Item: PM2

PCI-E 1X to mini pci express adapter

Reference Schematic Rev. 2.02

Title		
PCI-E 1x to Mini PCI-E adapter		
Size	Document Number	Rev
A3	MINI PCI-E CARD	2.02
Date: Thursday, June 10, 2010		Sheet 1 of 1
Bplus technology Co., Ltd.

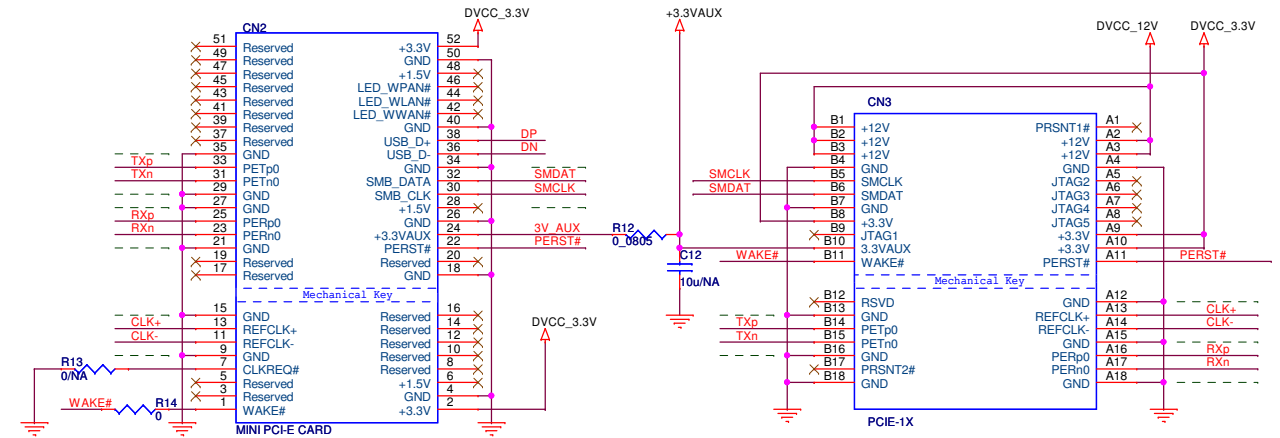
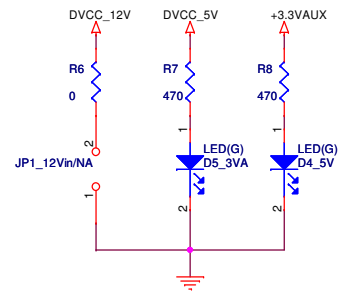
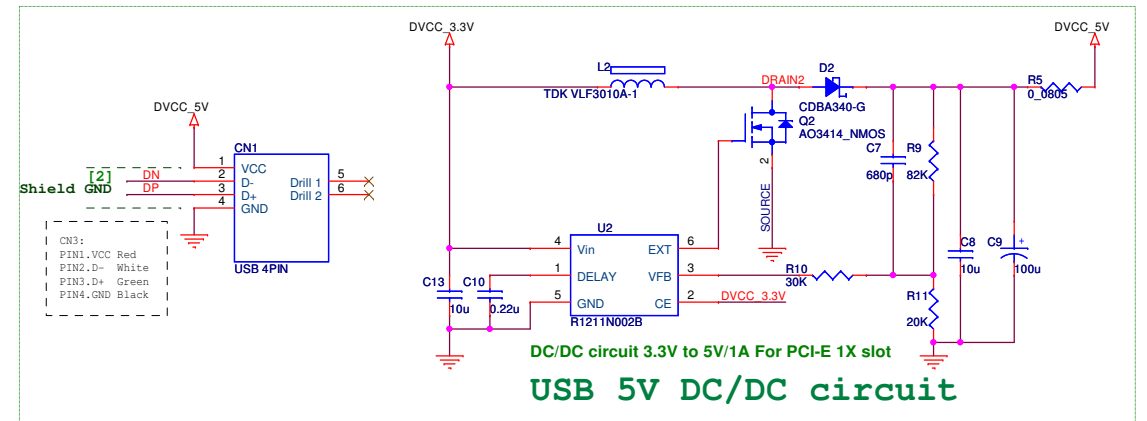
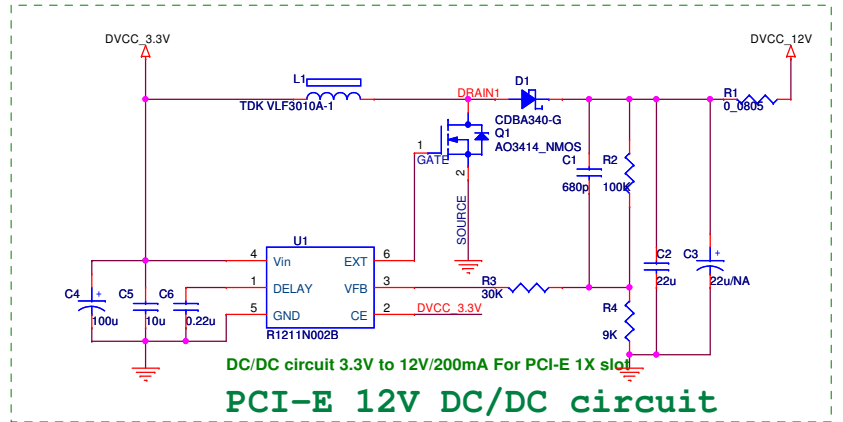
JP1/NA, C3/NA, C12/NA , C2 from 10u to 22u
